EDMS NO. 1973010	REV. 0.1	VALIDITY DRAFT
----------------------------	--------------------	--------------------------

REFERENCE LHC-TC-EC-0012

ENGINEERING CHANGE REQUEST

Installation in IR2 of dispersion suppressor collimators (TCLD)

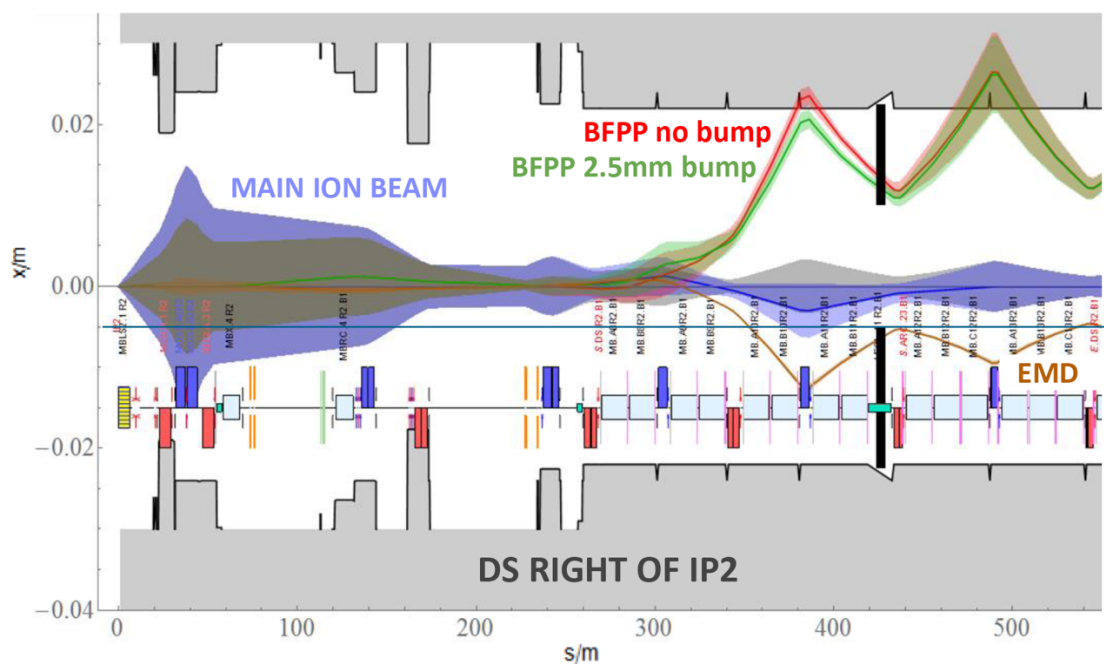
The magnets that are impacted by these losses are likely to quench at the high luminosities foreseen for HL-LHC. As alleviation, it is planned to install additional collimators (shown as black lines in Figure 1).

As can be seen in Figure 1, these secondary beams are lost very locally due to the large and sudden change of magnetic rigidity at the interaction point. After the LS2

ALICE upgrade, aiming at a peak luminosity of $6 \times 10^{27} \text{cm}^{-2} \text{s}^{-1}$ (about six times higher than the nominal one) [3], the dominant BFPP1 beam can carry about 155 W, resulting in a power load in the coils of the MB.B10 dipole of about 44 mW/cm^3 [4] on both sides of ALICE. Similar ion losses also occur in the DS regions around ATLAS and CMS, however at different locations than in IR2. A beam loss experiment carried out during the 2015 Pb-Pb run at 6.37 Z TeV [5] confirmed the long-standing presumption that BFPP1 ions risk to quench magnets [1,2]. The experiment was carried out around CMS because it was running at higher peak luminosity than ALICE. The deposited power during the quench was estimated with FLUKA simulations to be about a factor 6 lower than what is calculated for HL-LHC, hence this effect could be a serious limitation for HL-LHC.

During standard operation, special bumps were deployed around ATLAS and CMS to steer the BFPP1 losses into the locations of the connection cryostat, however, because of the quadrupole polarities in IR2, this solution alone is not possible at ALICE. Instead, the HL-LHC baseline is to install one additional collimator, called TCLD, on each outgoing beam in the IR2 dispersion suppressor, where the dispersion is already rising [3]. Orbit bumps allow making sure that the beam is not lost at the first (lower) dispersion peak (see Figure 1) and enable shifting the losses into the collimators. These TCLDs will also intercept the most powerful EMD beam (EMD1). FLUKA simulations have shown that the proposed TCLDs reduce the peak load on the magnets to tractable levels at HL-LHC design luminosity [4].

Figure 2 – One of the TCLD jaws, including RF fingers, cooling pipes and BPMs. Courtesy of L. Gentini.

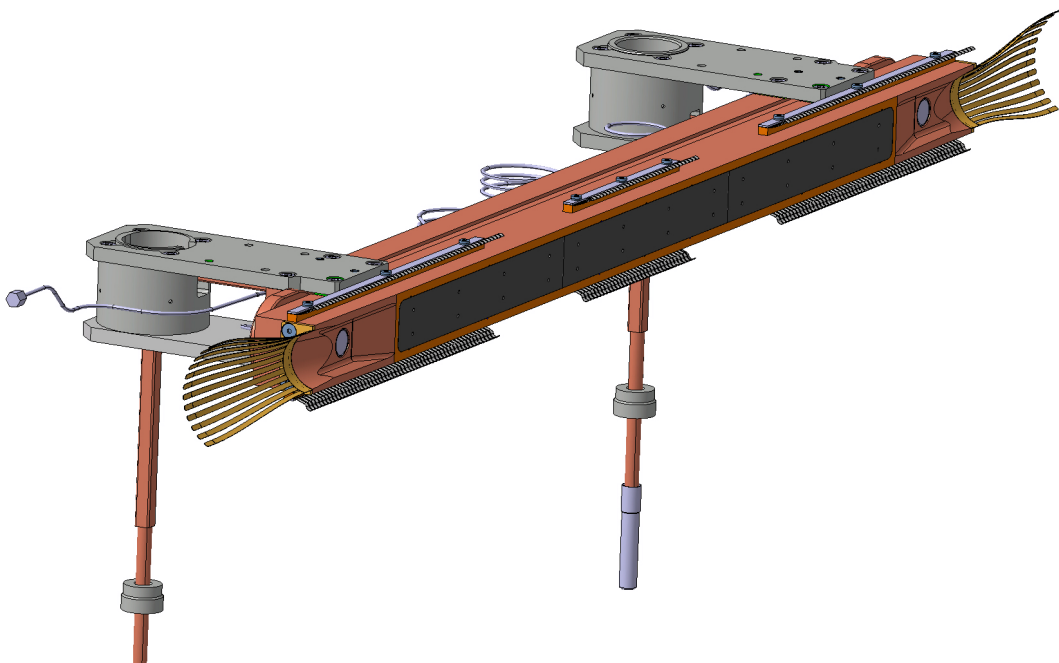
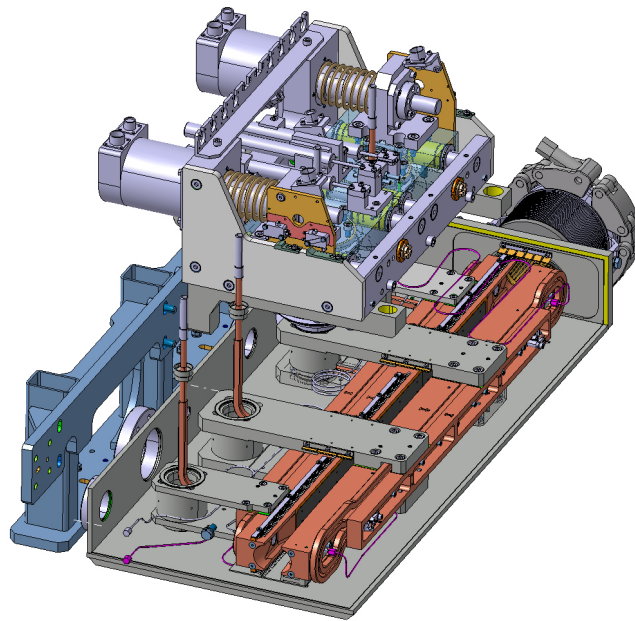
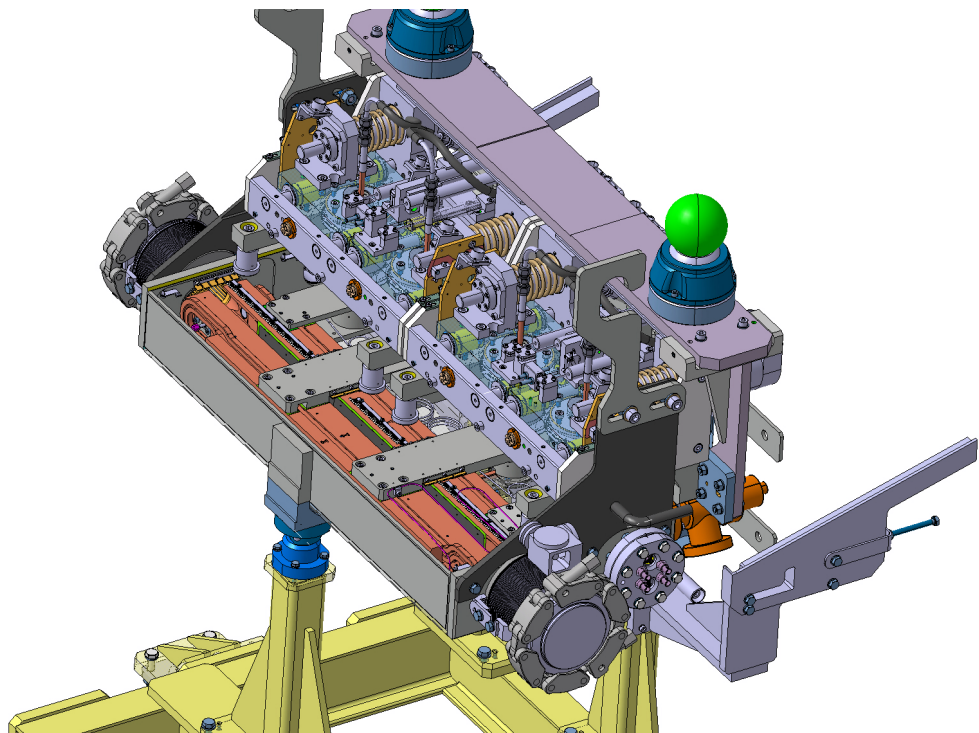
The TCLD consists, as most other LHC collimators, of two parallel jaws collimating the beam in the horizontal plane, with the beam passing in between them. The active material of the jaws is the tungsten alloy Inermet 180. The design of the TCLD collimator, shown in more detail in Figure 2, Figure 3 and Figure 4, is derived from the design of the present LHC collimators, but with some differences. Since the design of the IR2 TCLDs is identical to that of the IR7 ones, and because of the very tight space requirements in IR7, the design is challenging and the active length of the material had to be reduced to only 60 cm, in order to make it fit. This means that also a non-standard support design is used. Furthermore, the bellows at the two longitudinal extremities are integrated in the tank transitions in order to gain longitudinal space. A 3D drawing of the tank and support is shown in Figure 5.

The actuation system does not include any movement in the vertical plane, which allowed reducing the jaw height. Otherwise, each jaw can be independently moved by two stepping motors per jaw, which maintains the possibility to tilt the jaws in the

horizontal plane. The maximum opening of each jaw is 25 mm from the centre, 5 mm less than for standard collimators, and the stroke across the centre is 5 mm.

As all recent collimators, the design includes two BPMs per jaw, integrated at the extremities outside of the tapering. The jaws feature water cooling, using squared 9 mm pipes. Each jaw contains also 3 LVDT position sensors and 2 TP100 temperature sensors.

Figure 6 – The assembly to be installed between the at the location of the IP2 connection cryostats, consisting of TCLD collimator, support, beam pipe for the other beam, and cryo-bypass. Courtesy of L. Gentini.

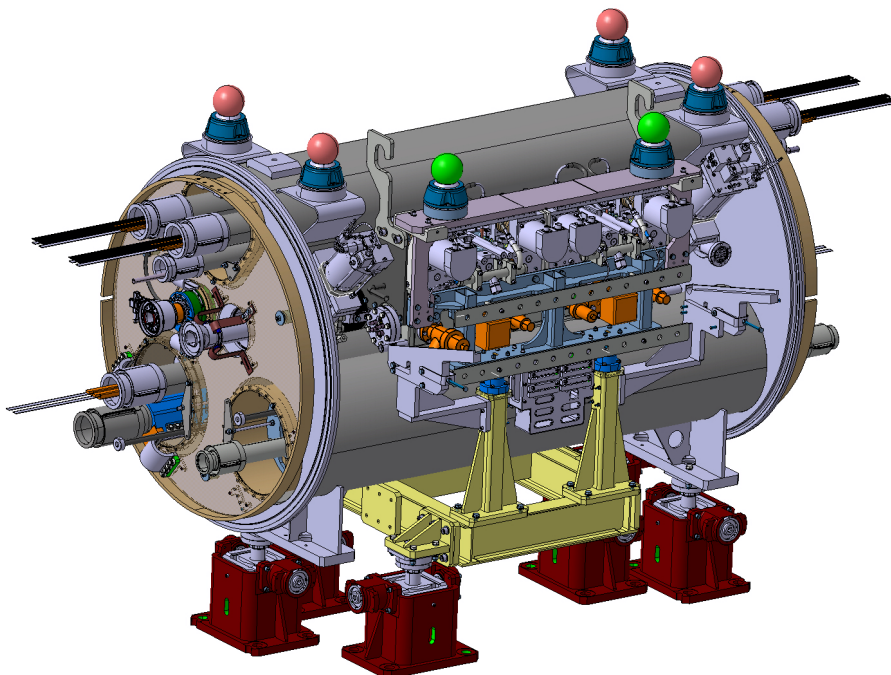
The TCLD will be integrated in a specially designed assembly, containing a beam pipe for the other beam, as well as a cryo-bypass, which is needed since the TCLD is a warm element placed between two cold ones. This assembly, which is discussed more in detail in a separate ECR, is shown in Figure 6.
